PLANNING, ZONING, & BUILDING DEPARTMENT  
PZ&B Staff Memorandum: Architectural Commission

SUBJECT: ARC-24-0113 1600 S OCEAN BLVD

MEETING: February 26, 2025 ARCOM

**ARC-24-0113 1600 S OCEAN BLVD.** The applicant, PB Pavilion Trust (Peter A. Flanagan, Robert G. Simes, & Michael Vineberg as Trustees), have submitted an application requesting Architectural Commission (ARCOM) review and approval for modifications to existing landscape and hardscape and modifications to the driveway gates and pedestrian gate at an existing single-family residence with ARCOM approved renovations and additions underway.

*Proposed vehicular gate and columns.*

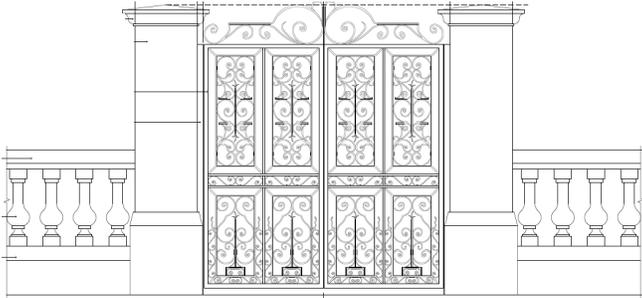
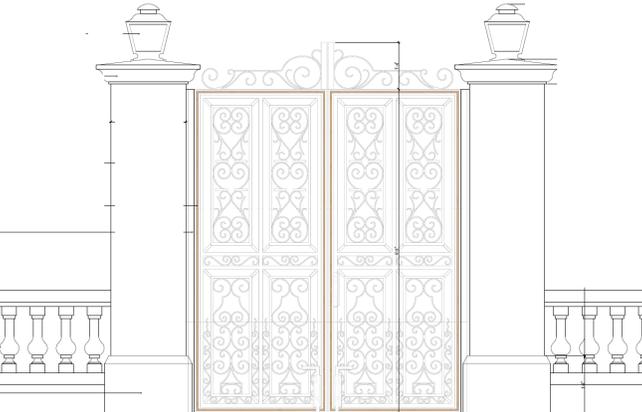
At the January 2025 ARCOM hearing, the commission was in agreement that the proposed landscape plan was acceptable but that further study was required for the pedestrian and vehicular gates. The applicant has resubmitted plans in response to comments of the commission. The applicant has restudied the scale of the columns, refined the detailing of the column bases and caps, and refined the detail in the gate designs.

*Proposed pedestrian gate and columns at dock.*

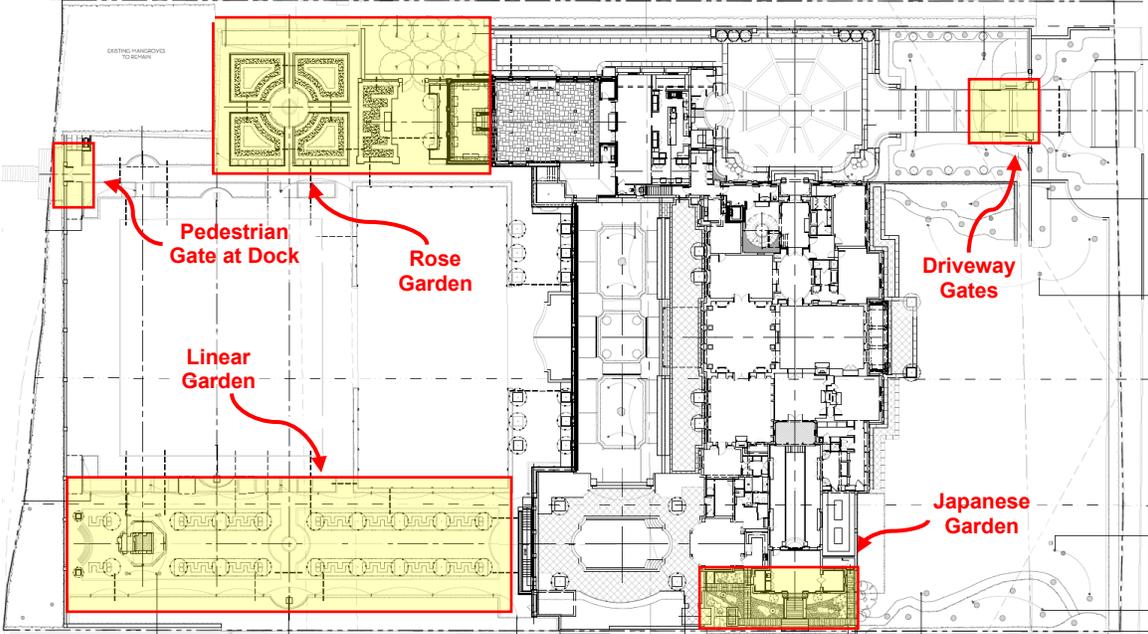
Additionally, modifications to the front site wall and the replacement and relocation of an existing vehicular gate outside of the front setback area are proposed. With the relocation of the vehicular gates outside of the required front yard setback area, the maximum 8 ft height limit for vehicular and pedestrian gates is eliminated. Minor landscape modifications are proposed in relation to the changes. A pedestrian gate at the dock is proposed to match driveway gates.

*Landscape Plan for Rose Garden*

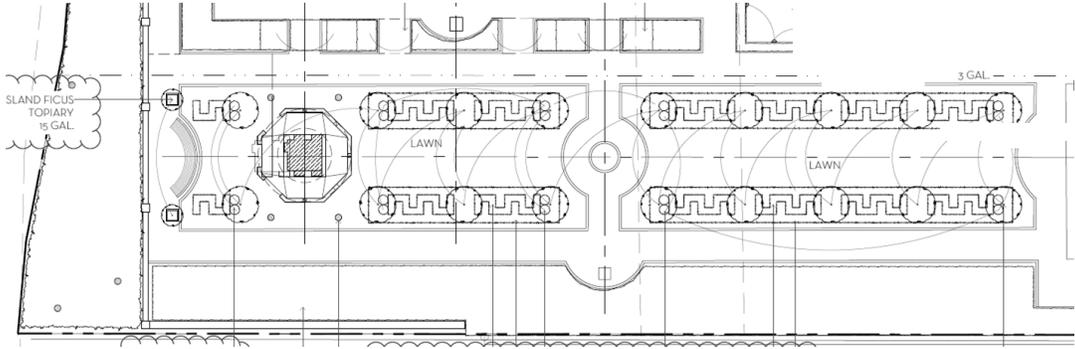
At the north-west part of the site, a formal rose garden area is proposed. Plantings in the garden include Rose bushes, Calophyllum hedges, Seagrape trees, Green Island Ficus, and potted citrus trees. Gravel pathways are proposed. Site walls with pedestrian gates are proposed to border the garden on the north and west sides, including new fountains. Staff will note that the artificial turf noted on sheet L1 is proposed on top of an upper floor terrace and not over landscape open space.

*Landscape plan for linear garden.*

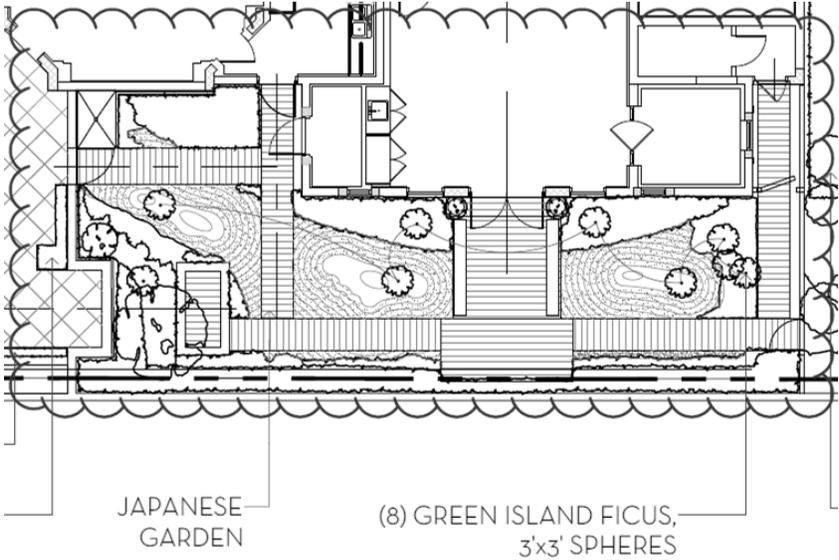
A linear garden is proposed at the south-west of the site, incorporating the folly structure which houses the cooling tower into the design. This garden area will feature gravel pathways,

Calophyllum hedges, Green Island Ficus topiaries, coconut palms, Ilex mounds and hedges, jasmine minima, and lawn area.
